S E R V I C E N O T E

**8664A Synthesized Signal Generator**

**I/O Assembly Replacement requires modification to Reference Assembly**

**FIGURE 1**

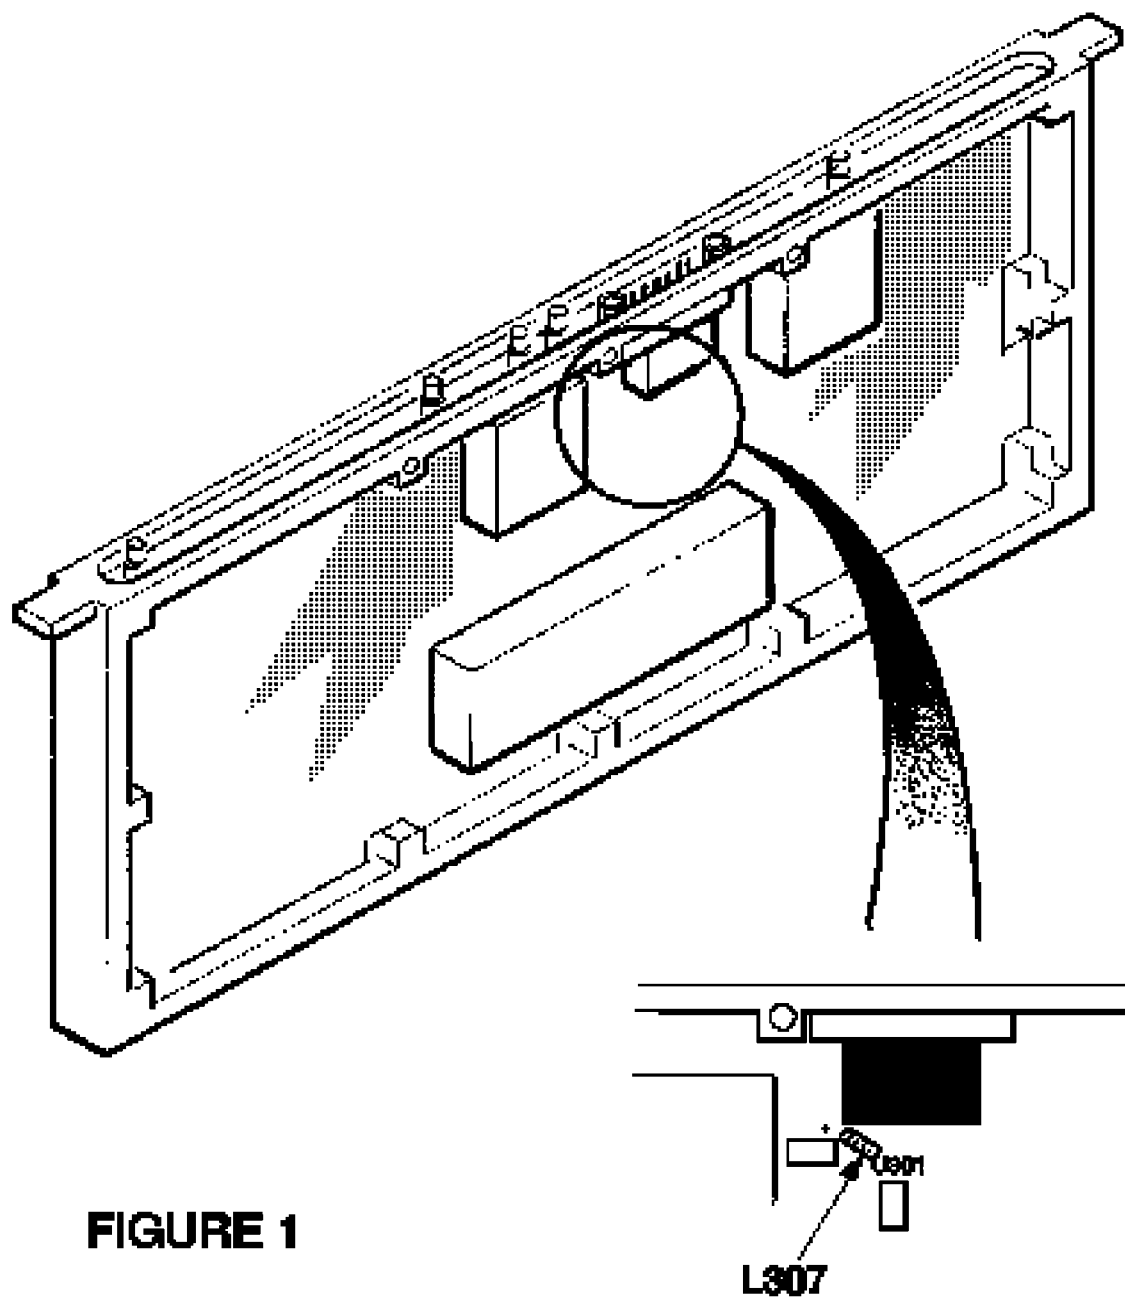
When an I/O assembly (08665-69104 or 08665-60204) is replaced in instruments (serial numbers noted above) a component on the Reference assembly (P/N 08665-61006) must be removed to insure proper operation of the reference oscillator.

Remove L307 on the Reference assembly. Refer to Figure 1 for component location. Re-calibration is not required.
